SUBJECT: **Request for Modification to the Section 404 Individual Permit and Section 401 Water Quality Certification** for the proposed Greensboro Western Loop from north of SR 2176 (Bryan Boulevard) to SR 2303 (Lawndale Drive), Guilford County, Division 7. Federal Aid Project No. STP-NHF-124(1), WBS Element No. 34820.1.2, TIP No. U-2524C and D.

REFERENCE: USACE Individual Permit Action ID SAW-2001-21125, dated August 1, 2013.
USACE Individual Permit Modification Action ID SAW-2001-21125, dated March 25, 2014.
USACE Individual Permit Modification Action ID SAW-2001-21125, dated June 19, 2015.
NCDWR Project No. 20130223, Certification No. 3965, dated July 2, 2013.
NCDWR Project No. 20130223_v2, Modification to Certification No. 3965, dated April 15, 2014.
NCDWR Project No. 20130223_v3, Modification to Certification No. 3965, dated June 25, 2015.

PROJECT REFERENCE NO. U-2524C	SHEET NO. 10
RW SHEET NO.	
ROADWAY DESIGN ENGINEER	HYDRAULICS ENGINEER
PRELIMINARY PLANS DO NOT USE FOR CONSTRUCTION	
PERMIT DRAWINGS Rev. SHEET 9 OF 39

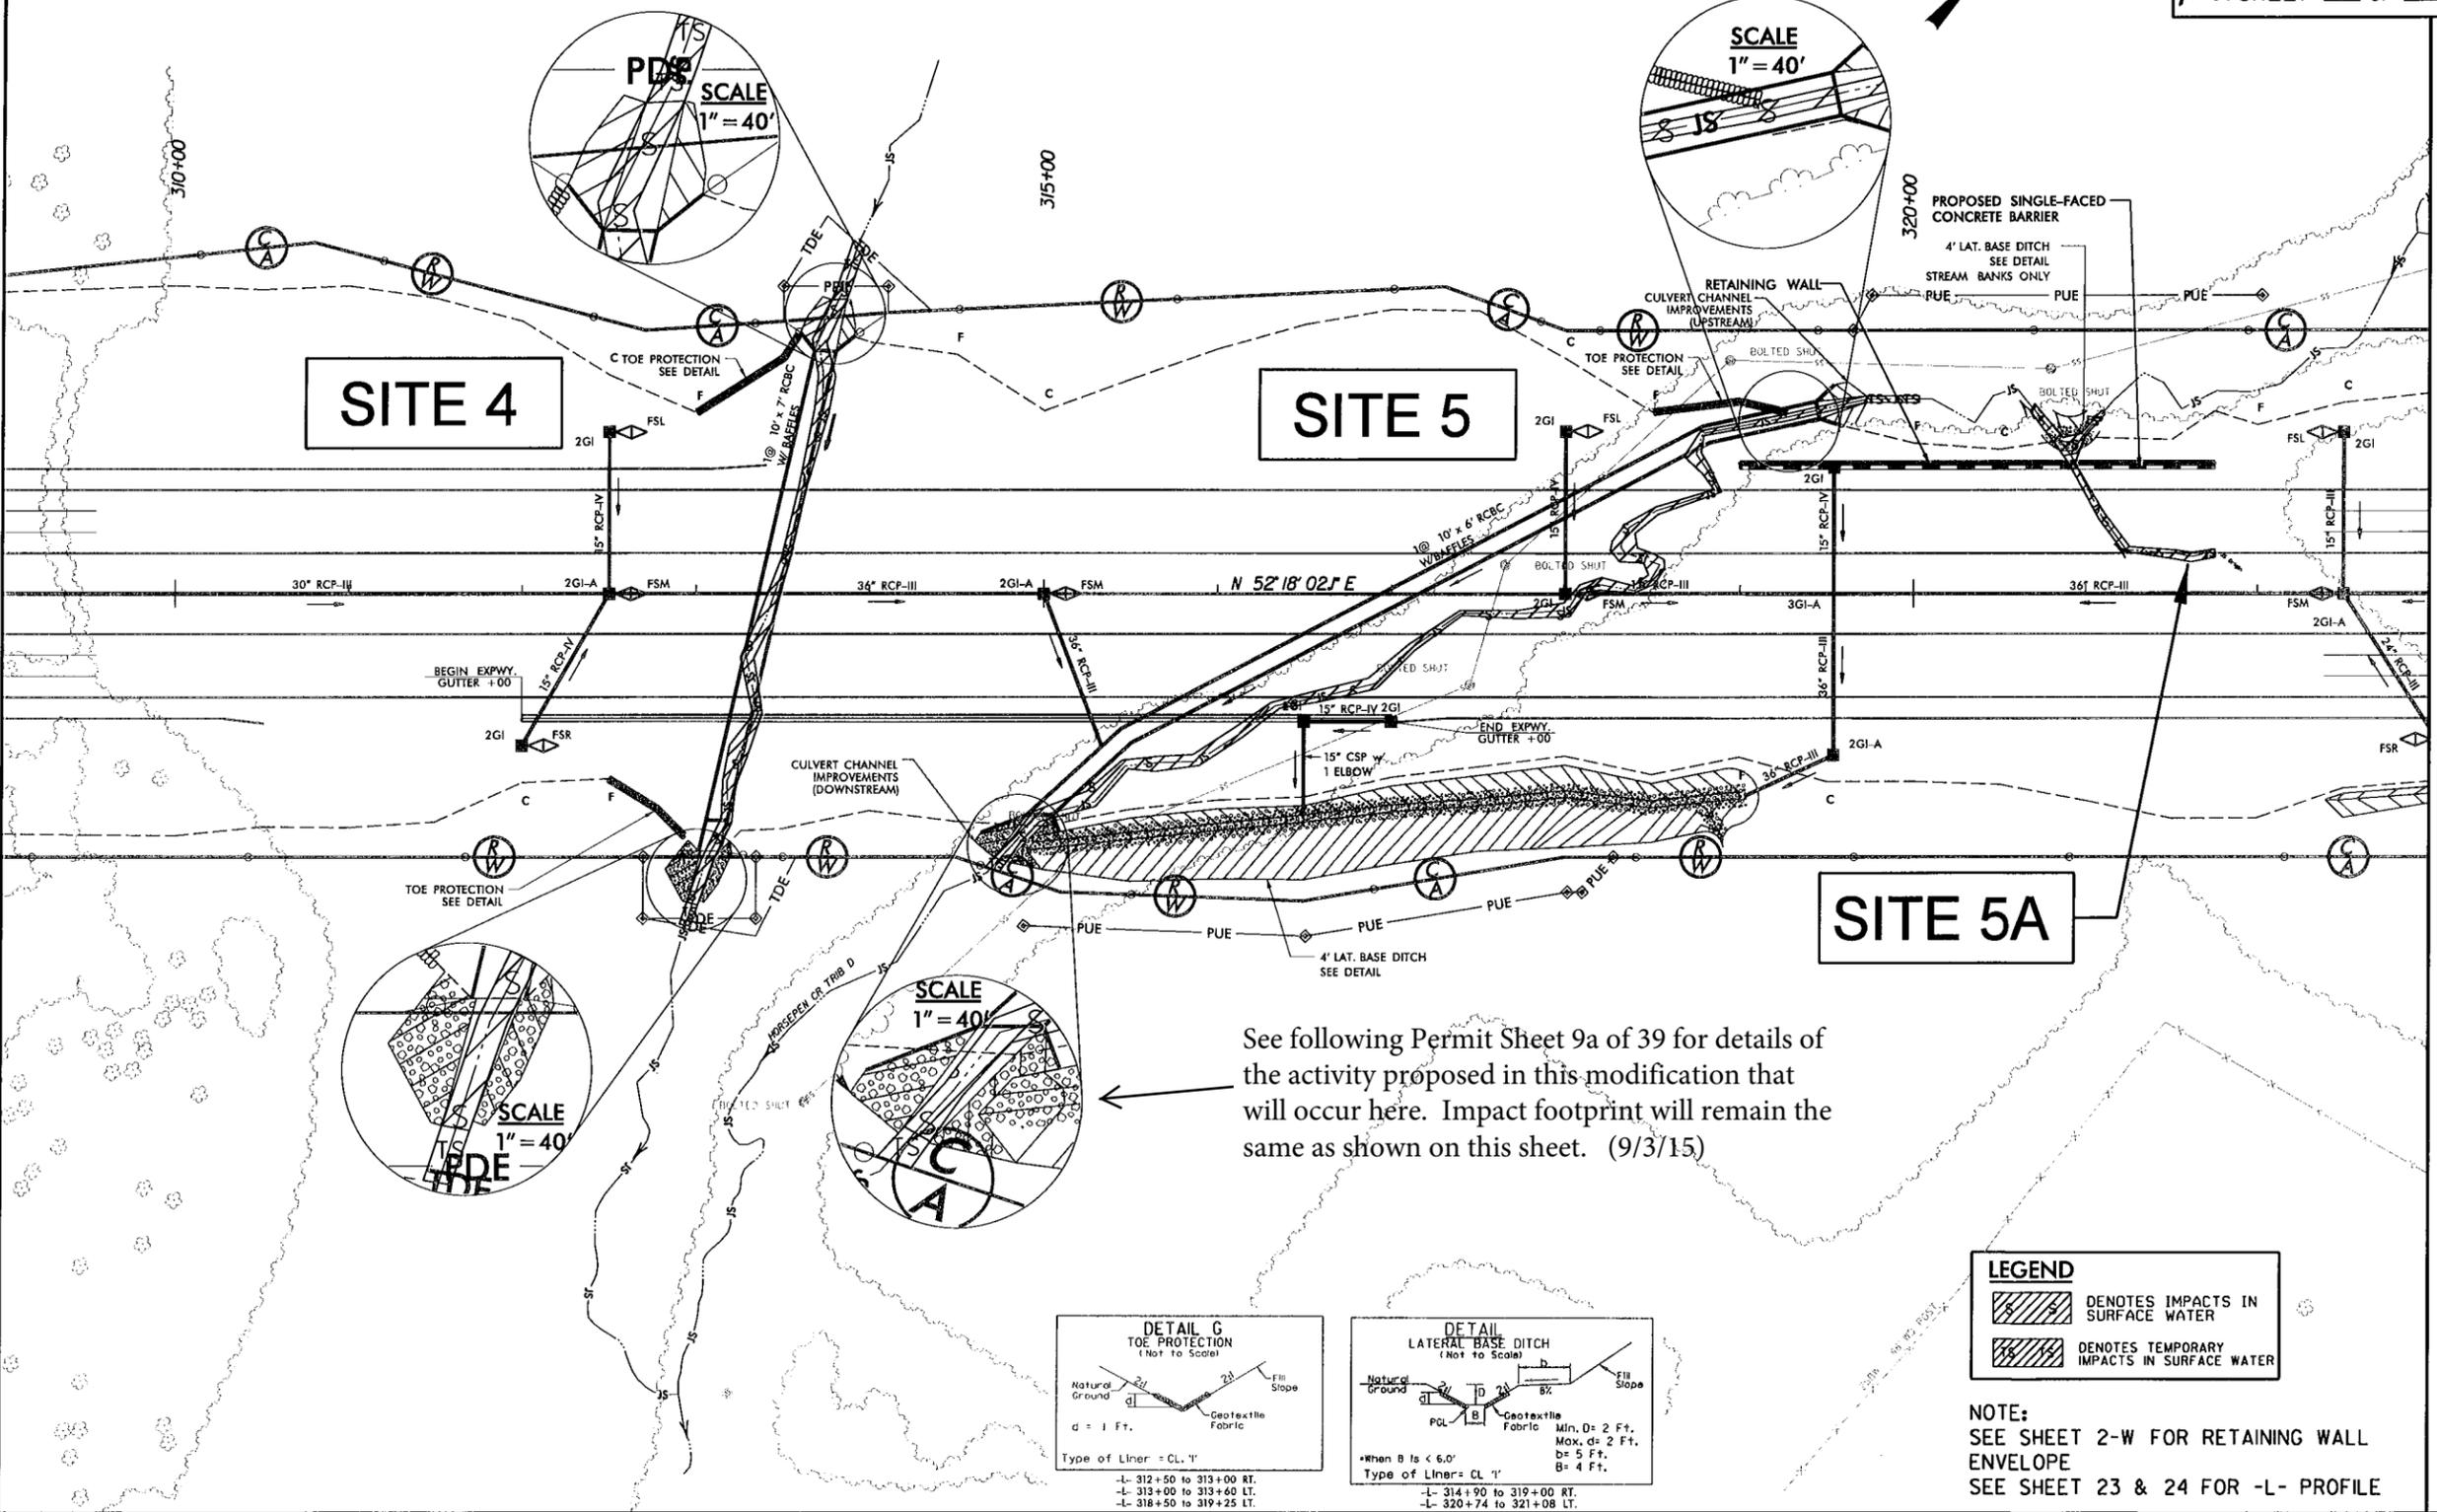
Once the new 10'x6' reinforced concrete pipe culvert (RCBC) was constructed at Permit Site 5, it was discovered that water was flowing under the culvert. The Division believes that this is groundwater that was trapped during the backfilling of the culvert. This flow is detrimental to the structure foundation and could eventually cause settlement of the new structure or collapse of the wing walls.

After consultation with the Geotechnical Unit, the NCDOT proposes removing the streambed material from the area within the wingwalls to an elevation below the culvert footing. Then place geotextile fabric

and rip rap mixed with the excavated material and cap with a one foot layer of the original streambed material. This activity would occur within the same footprint for which the 37 linear feet of bank stabilization was originally proposed at this site. Please see Table 1 below and the attached revised Permit Drawing Sheets 9, 9A and 39. Table 2 on page 3 has been updated to show current required mitigation from the NC Division of Mitigation Services (DMS) for Section C. The revised DMS acceptance letter, dated September 21, 2015, is attached.

See following Permit Sheet 9a of 39 for details of the activity proposed in this modification that will occur here. Impact footprint will remain the same as shown on this sheet. (9/3/15)

GUILFORD COUNTY
U-2524C
Revised 9/3/15
SHEET 39 OF 39 9/3/2015

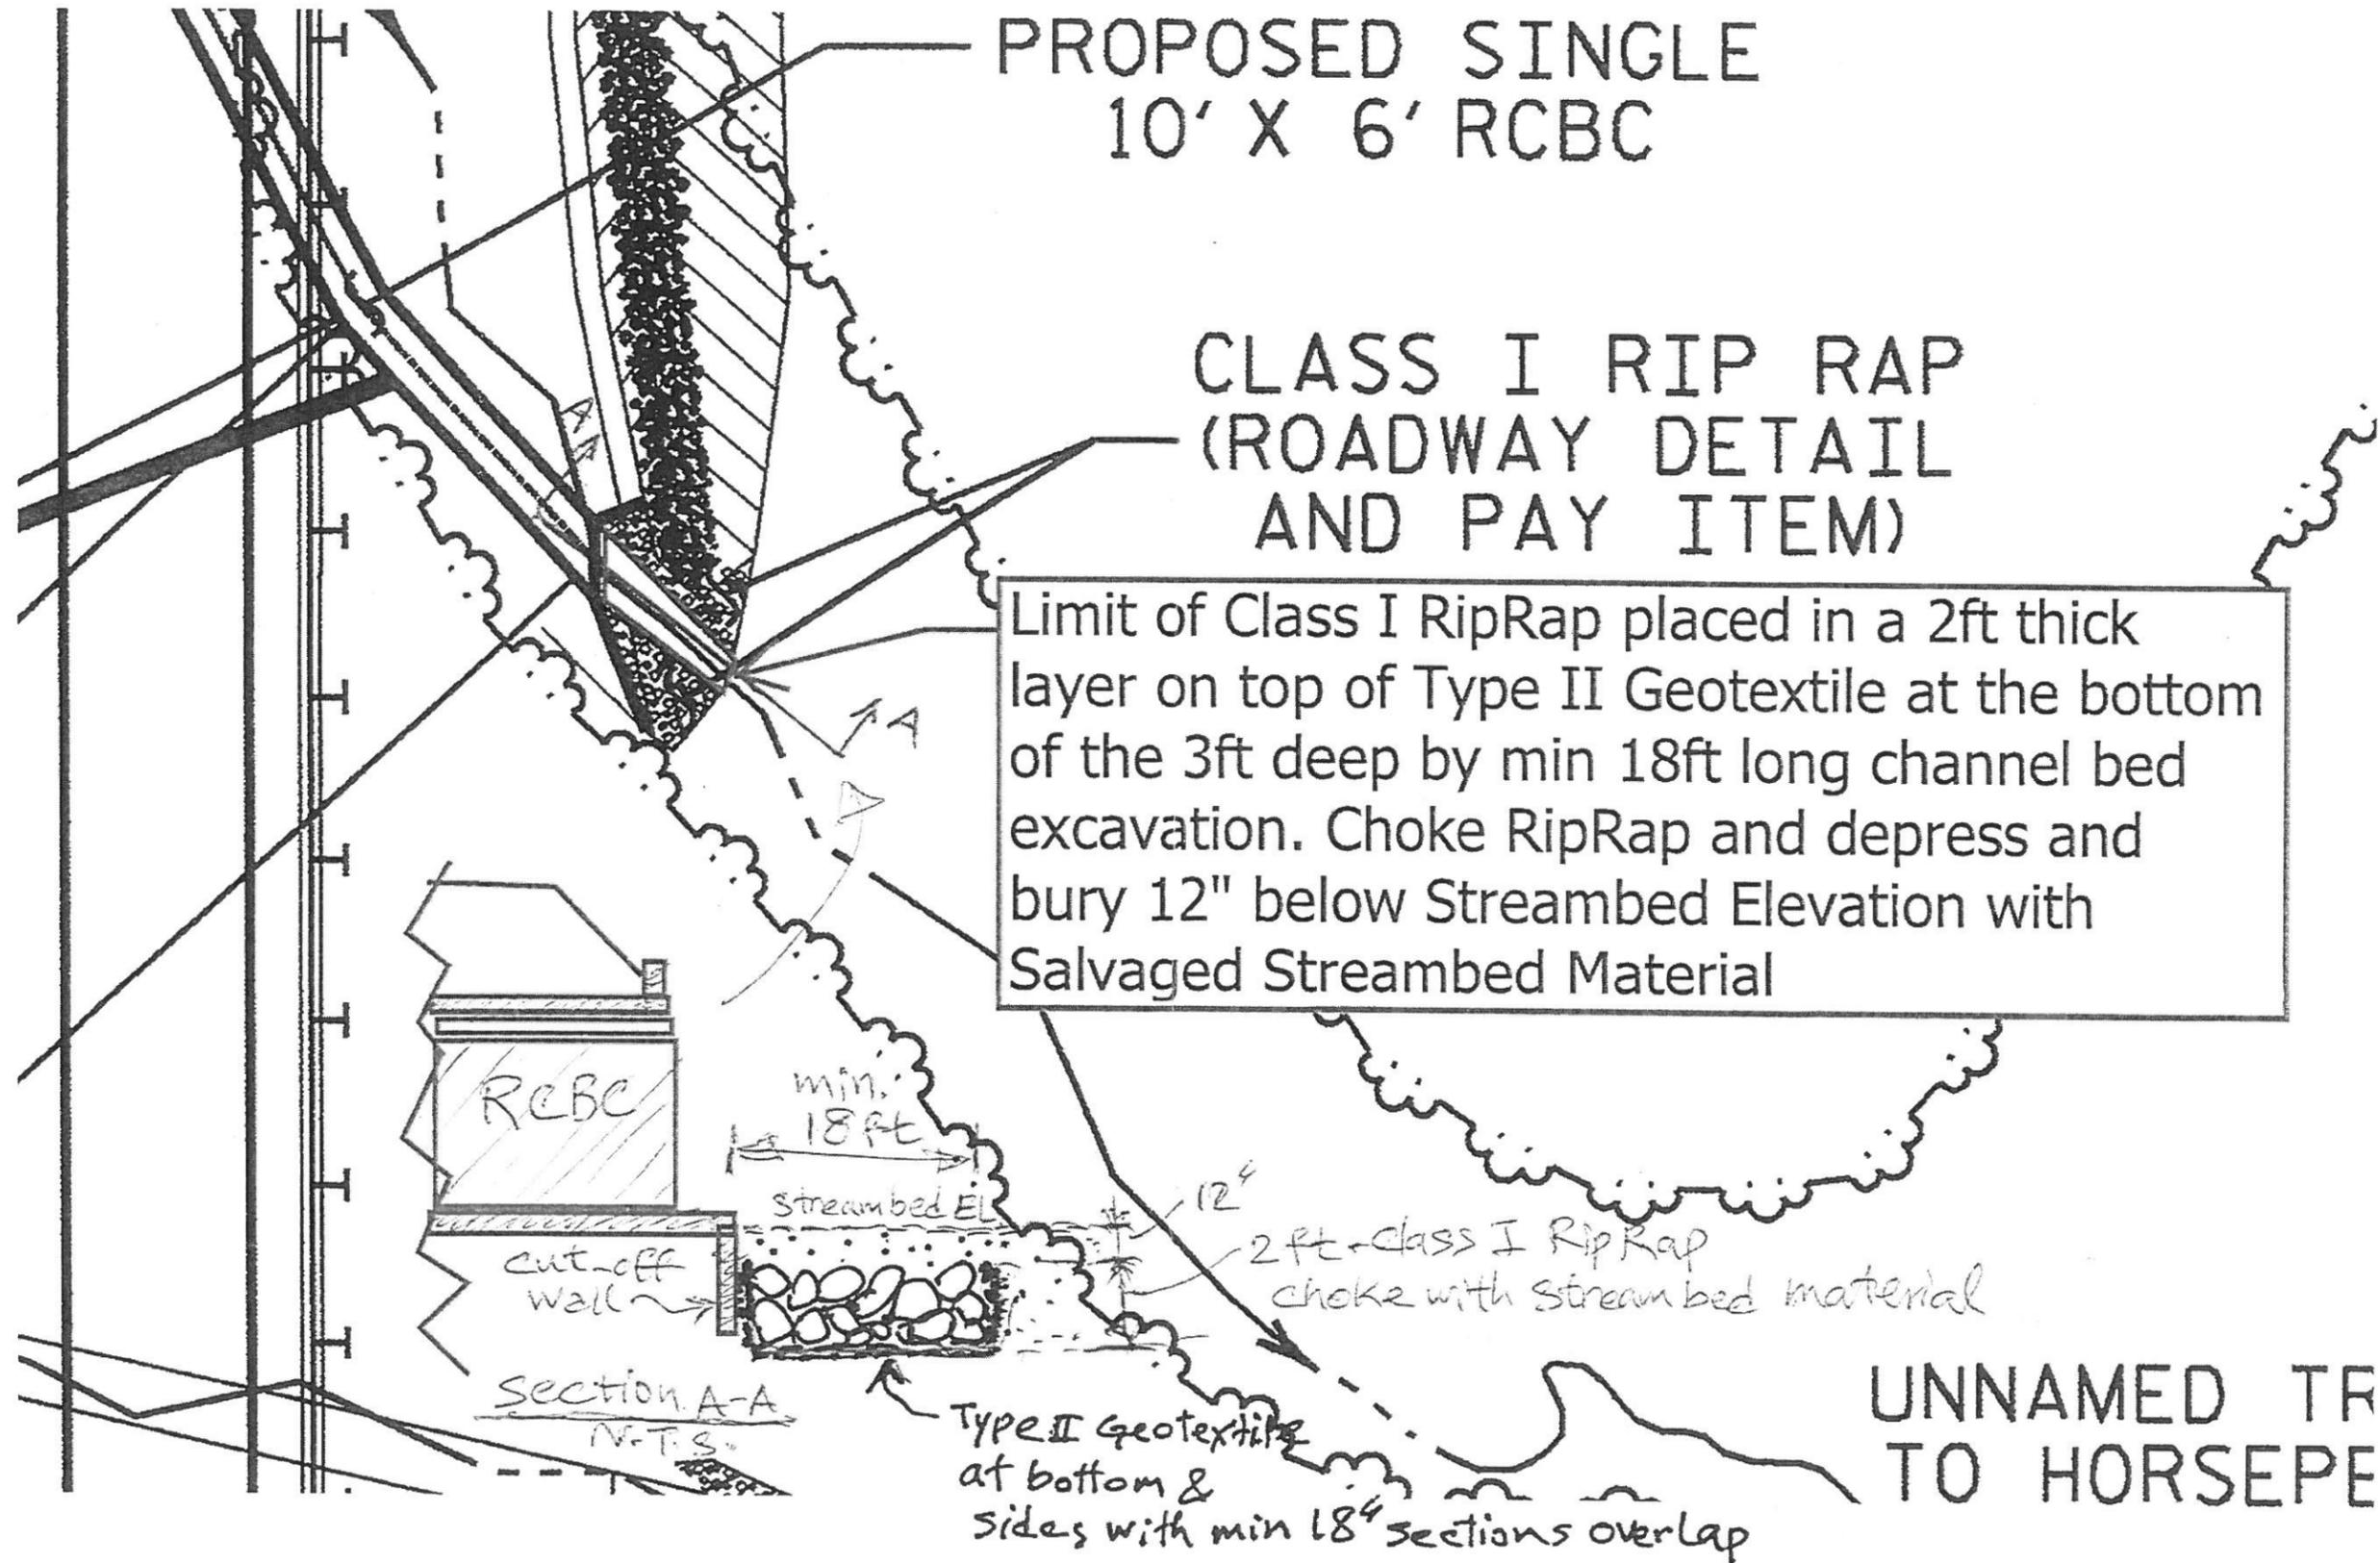
4	-L- 312+90 TO 313+91	1 @ 10' x 7' RCBC	-	-	-	-	-	0.06	0.01	331	46	-
	-L- 312+95 TO 313+13	Bank Stabilization	-	-	-	-	-	-	-	30	-	-
5	-L- 314+67 TO 321+11	1 @ 10' x 6' RCBC	-	-	-	-	-	0.10	0.01	688	40	-
	-L- 314+72 TO 315+05	fill	-	-	-	-	-	-	-	37	-	-
5A	-L- 320+86 TO 321+95	Roadway	-	-	-	-	-	0.01	-	90	-	-
	-L- 320+78 TO 321+04	Bank Stabilization	-	-	-	-	-	-	-	25	-	-
6	-L- 323+60 TO 324+44	-	-	-	-	-	-	0.04	0.01	60	15	-
7	-L- 345+01 TO 345+88	30" RCP	0.01	-	-	-	-	0.03	0.01	227	10	-
	-L- 345+74 TO 345+85	Bank Stabilization	-	-	-	-	-	-	-	11	-	-
7A	-L- 345+02 TO 345+49	Roadway	-	-	-	-	-	0.01	-	57	-	-
8	-L- 358+77 TO 360+29	54" RCP	-	-	-	-	-	0.05	0.01	412	20	-
	-L- 359+46 TO 359+57	Bank Stabilization	-	-	-	-	-	-	-	13	-	-
9	-L- 380+47 TO 382+86	Bridge	-	-	-	0.02	0.40	-	-	-	-	-
10	-L- 387+31 TO 387+46	Bank Stabilization	-	-	-	-	-	0.01	-	16	-	-
10A	-Y3DET- 11+23 TO 13+92	Temporary Detour	-	0.01	-	0.01	-	-	-	-	-	-
